Under the **Resource Management Act 1991**

For: City Rail Link
Notice of Requirement 6 / Plan Modification 349
Lodged by Auckland Transport

Statement of Evidence by Catherine Lynda Heppelthwaite

Figure 1: Location Diagram

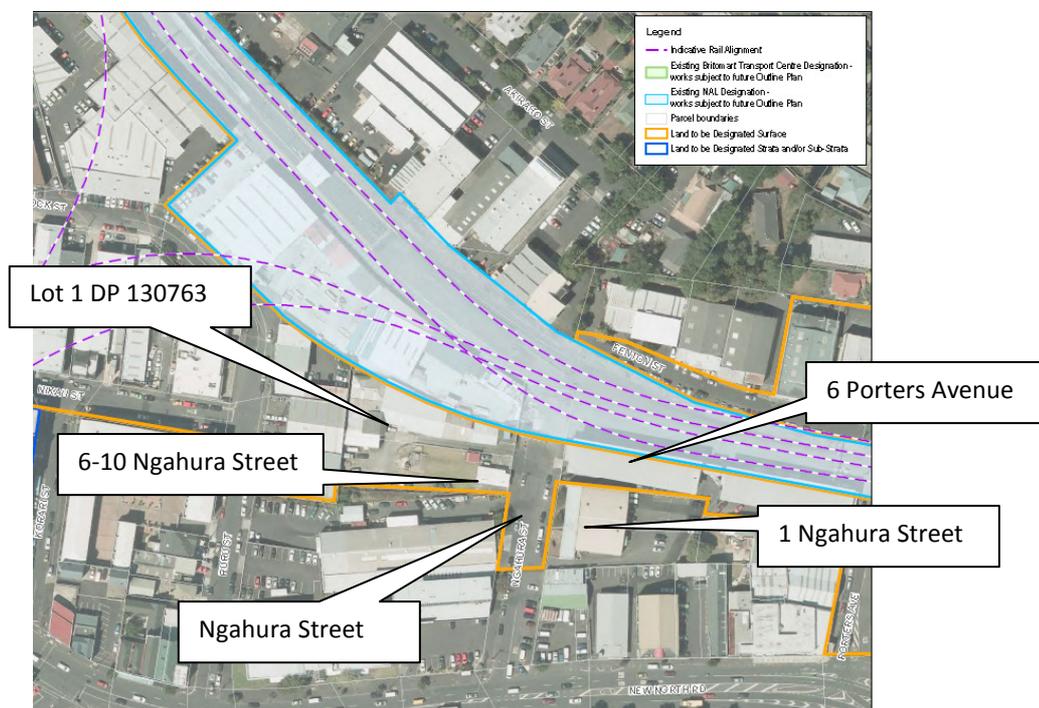
13. As noted in Figure 1 above, the ABA building is immediately adjacent to the proposed works and a likely key heavy vehicle access point to Construction Yard A.
